Site Accessibility Evaluation

Americans with Disabilities Act Title II (Public Services: State and Local Government)

**3755 Mark Dabling Blvd
Northeast Colorado
Springs, CO 80907**

Accessibility Evaluation

Finding #3 Continued

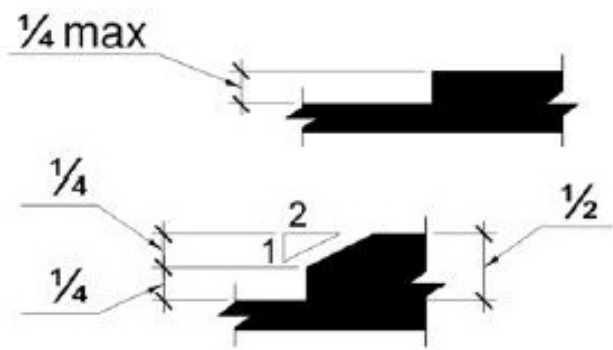
The walkway contains abrupt vertical edges and/or variations over a 1/4 inch.

Change in elevation
greater than 1/4 inch

When resurfacing parking lot, ensure elevation changes are no greater than 1/4 inch. Also, path of travel from access isle next to van accessible stall should be no greater than 5% running slope and no greater than 2% cross slope leading up to the main entrance.

Finding #4 Continued

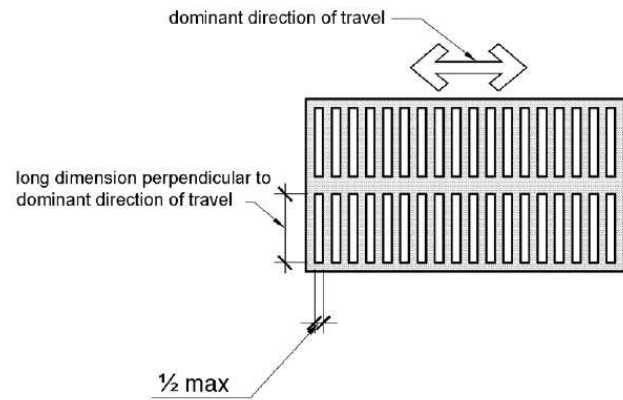
The concrete expansion joint is spaced greater than a 1/2 inch.

The concrete joint is spaced greater than a 1/2 inch.

When parking lot is resurfaced, ensure a smooth transition from asphalt to concrete to avoid an elongated opening greater than 1/2 inch.

Finding 297059 Main Photo

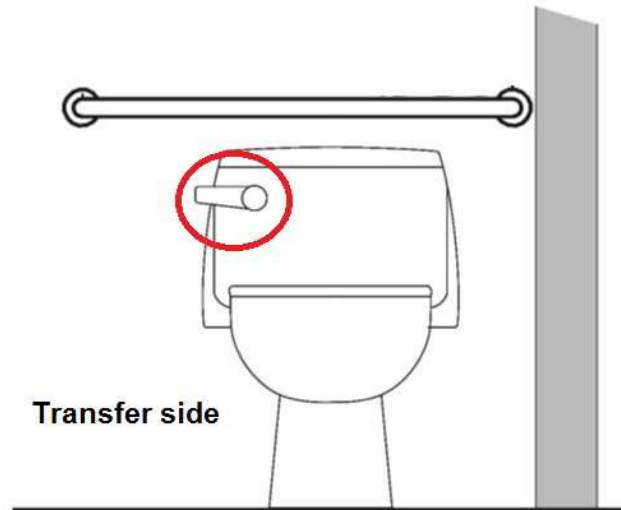
The flush handle is located on the wrong side of the toilet.

Flush handle on wall side

Replace toilet water tank with one that has flush handle on the opposite side (open side of toilet area).

Finding 297060 Main Photo

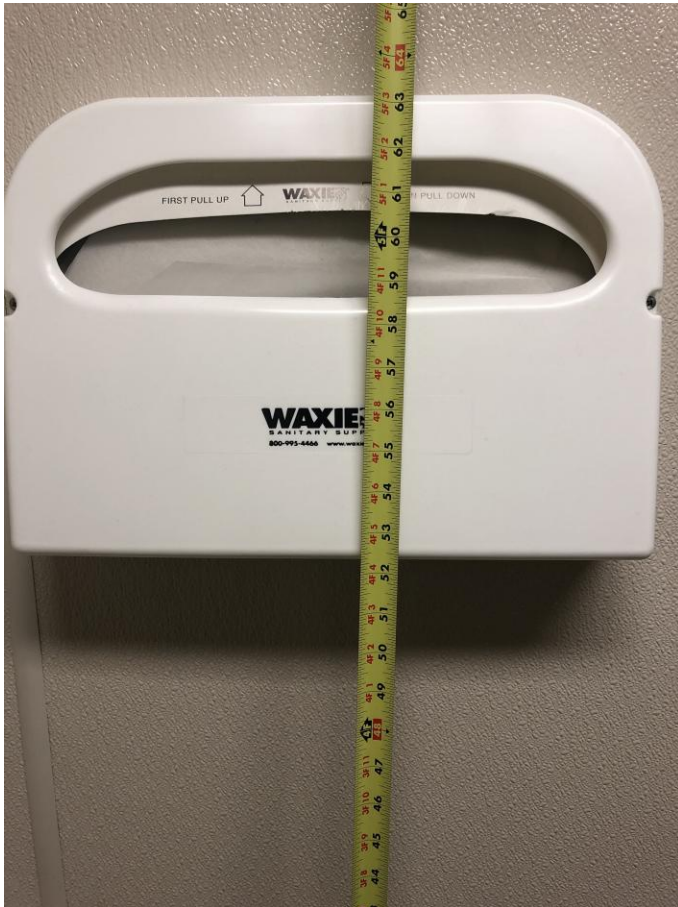
The toilet seat cover dispenser is mounted too high and are not located in an accessible location.

58 inches above
finished floor

Relocate seat cover dispenser to have operable part between 15 inches minimum and 48 inches maximum above floor. May require relocation below rear or side grab bar at 1.5 inches minimum clearance below grab bar to meet compliance.

Finding 297061 Main Photo

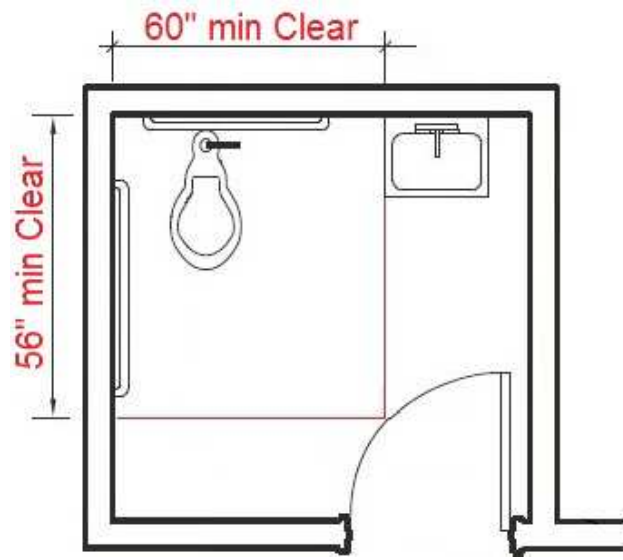
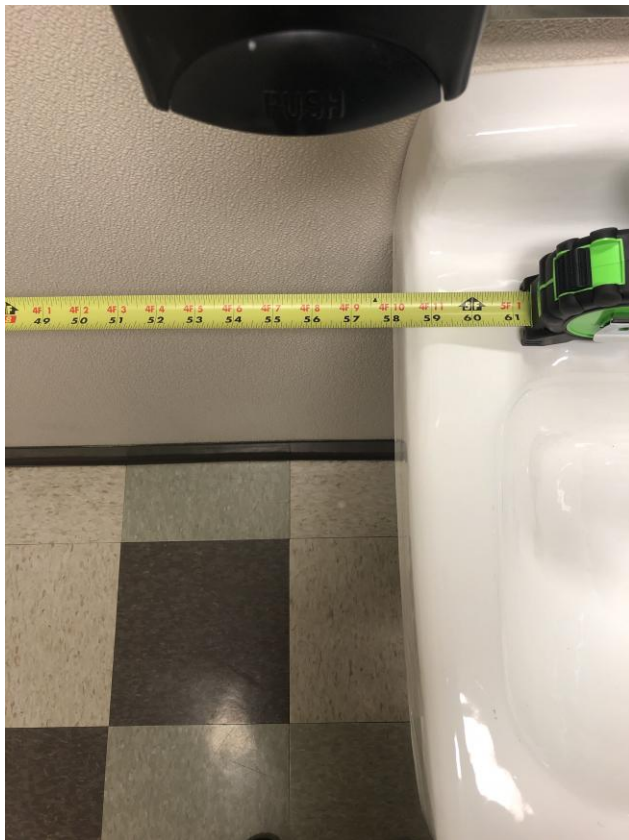
The clear floor space between the lavatory and the toilet is too narrow.

Lavatory protrudes into required clear floor space of the water closet

Relocate lavatory 2 inches further away from toilet in order to meet the minimum ADA 60 inch requirement.

Finding 297062 Main Photo

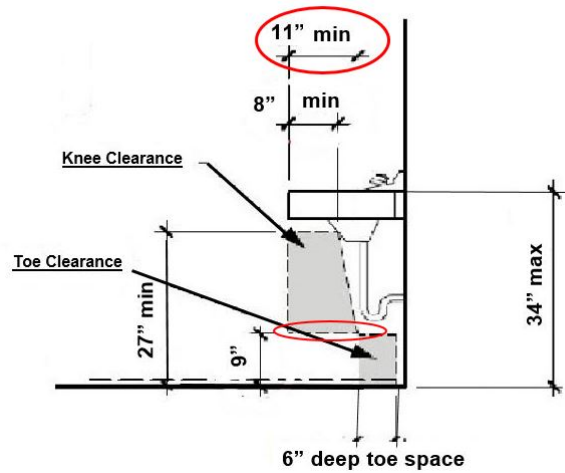
Compliant knee space has not been provided under the lavatory.

25.5 inches of knee clearance at 8 inches from front

Adjust or replace lavatory with one that provides a minimum height from the bottom edge of no less than 27 inches above finished floor and 8 inches minimum in depth for knee clearance.

Finding 297063 Main Photo

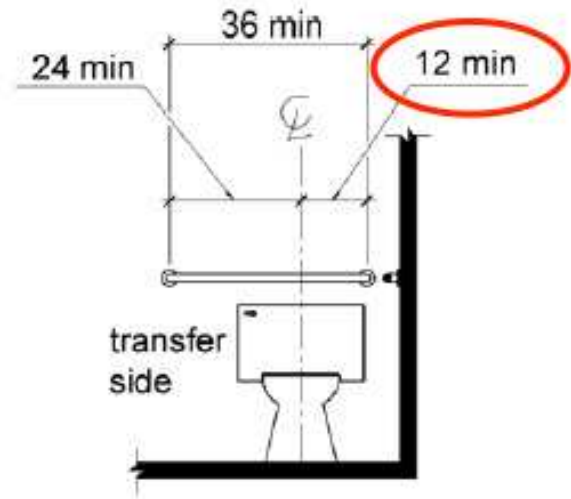
The rear grab bar does not extend adequately past the centerline of the toilet on the wall side.

10 inches from toilet centerline

Re-position rear grab bar to extend from the centerline of the toilet 12 inches minimum to the wall side and 24 inches minimum to the transfer/open side.

Finding 297064 Main Photo

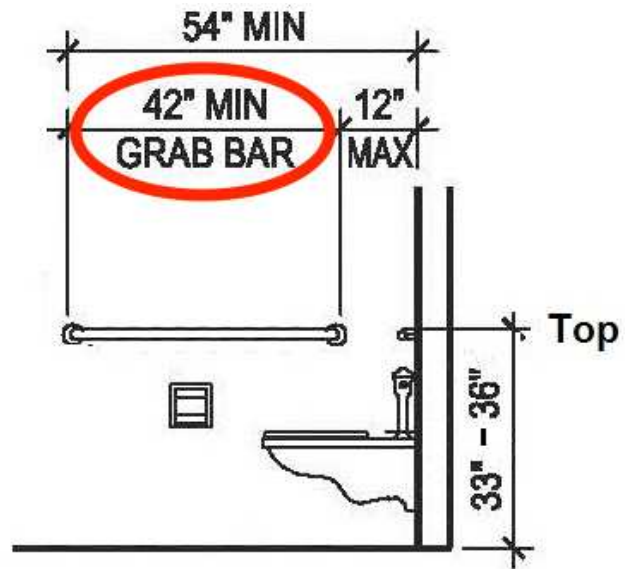
The side grab bar is not long enough.

6 inches from rear wall

Adjust side grab bar not to exceed 12 inches from rear wall measured to the centerline of the grab bar. The side grab bar must be 42 inches minimum in length and extend at least 54 inches minimum beyond the rear wall measured to the centerline of the grab bar.

Finding 297065 Main Photo

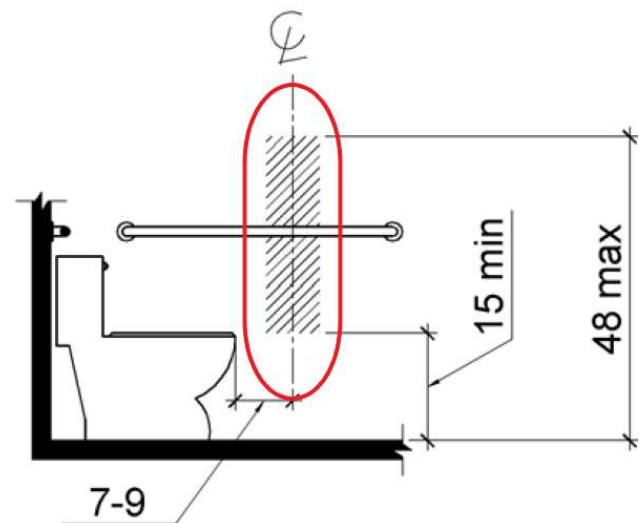
The toilet paper is not installed within the compliant height range.

12 inches in front of toilet

Re-position toilet paper dispenser to be within 7 inches minimum to 9 inches maximum in front of the toilet measured to the centerline of the dispenser.

Finding 297067 Main Photo

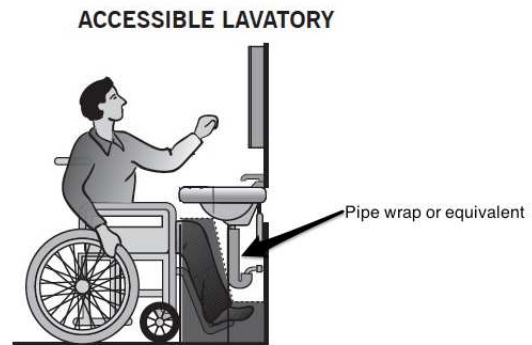
The water and drain pipes under the lavatory are not adequately insulated.

No drain pipe
insulation underneath
lavatory

Insulate drain pipes underneath lavatory.

Finding 297068 Main Photo

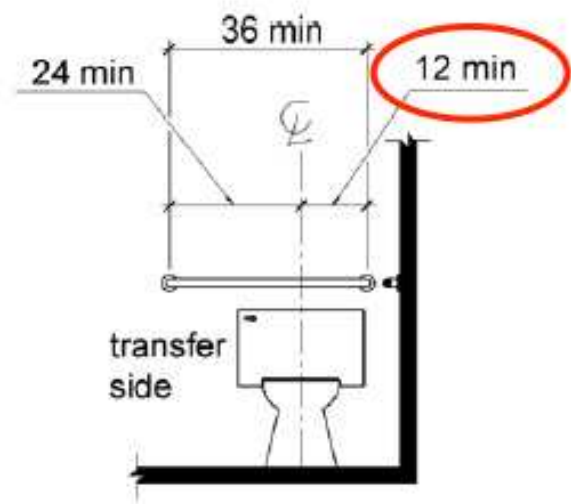
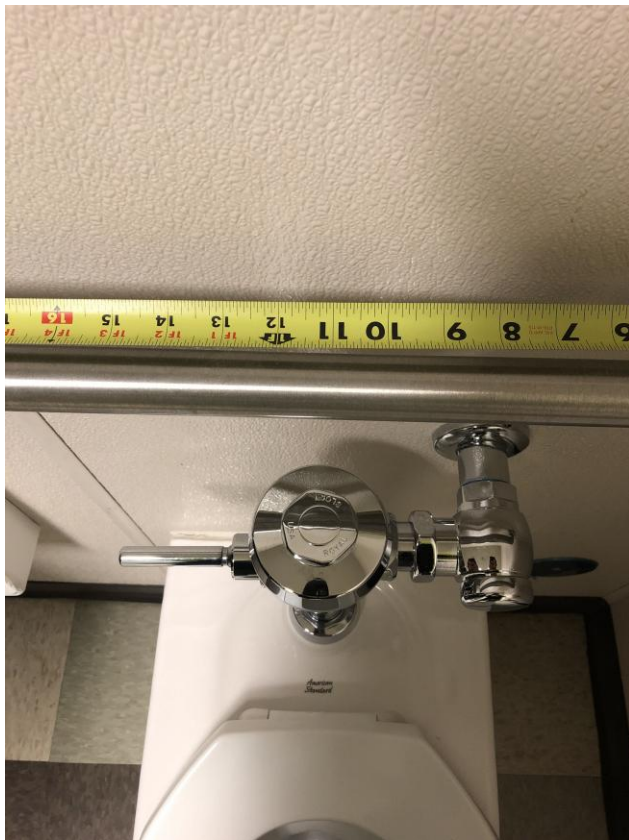
The rear grab bar does not extend adequately past the centerline of the toilet on the wall side.

Rear grab bar 11
inches from side wall

Re-position rear grab bar to extend from the centerline of the toilet 12 inches minimum to the wall side and 24 inches minimum to the transfer/open side.

Finding 297069 Main Photo

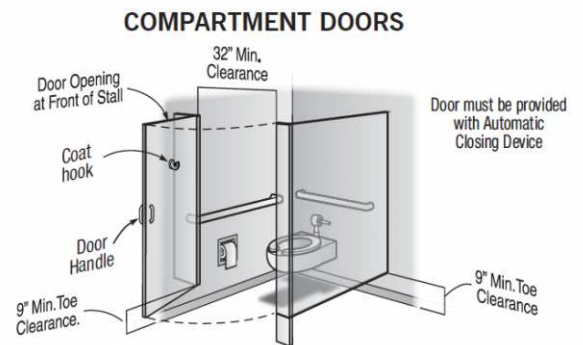
The compartment door is not self closing.

Compartment door not self closing

Re-adjust or replace door hinges to ensure compartment door is self closing.

Finding 297070 Main Photo

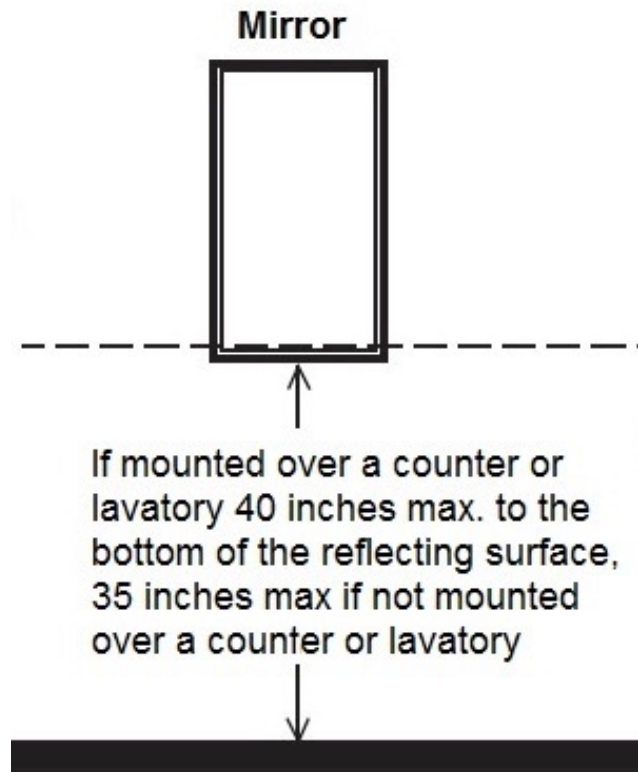
The mirror is mounted too high.

43 inches above
finished floor

Lower mirror to a maximum of 40 inches above finished floor measured to the bottom edge of the reflective surface or add another mirror.

Finding 297071 Main Photo

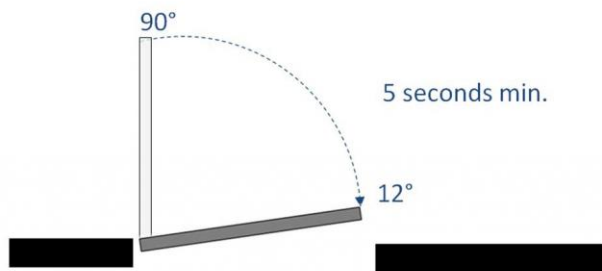
The door is equipped with a door closer and returns to a closed position too quickly.

2 seconds to closed position

Adjust door closer to allow a minimum of 5 seconds to move from the open position at 90 degrees to 12 degrees from the latch/locking mechanism.

Finding 299379 Main Photo

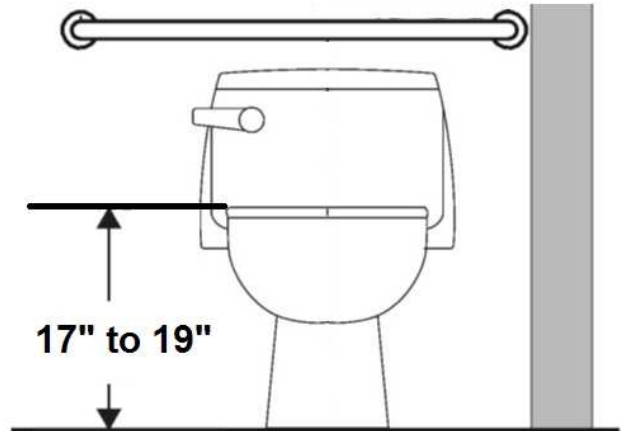
The toilet seat is not located within the range allowed off the floor.

Ambulatory stall toilet
seat height at 15
inches above finished
floor

Adjust toilet height, replace toilet or replace toilet seat with one that will meet the minimum height of 17 inches but no more than maximum height of 19 inches.

Finding 299381 Main Photo

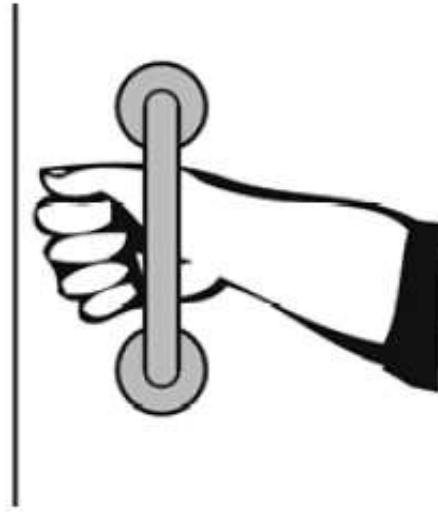
The water closet compartment door is missing a loop handle.

Ambulatory stall
missing both loop
handles

Install loop or U-shape handles on the inside and outside of the compartment door. Between 36 - 40 inches preferred.

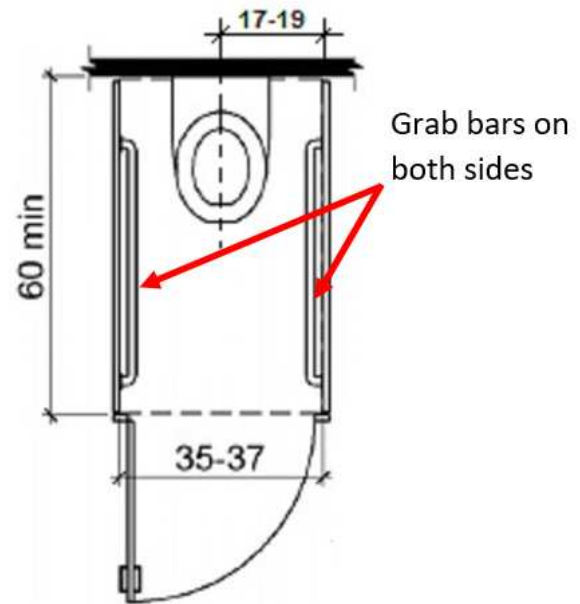
Grab bars are not installed on both sides of the compartment.

Grab bars missing on
both sides in
ambulatory stall
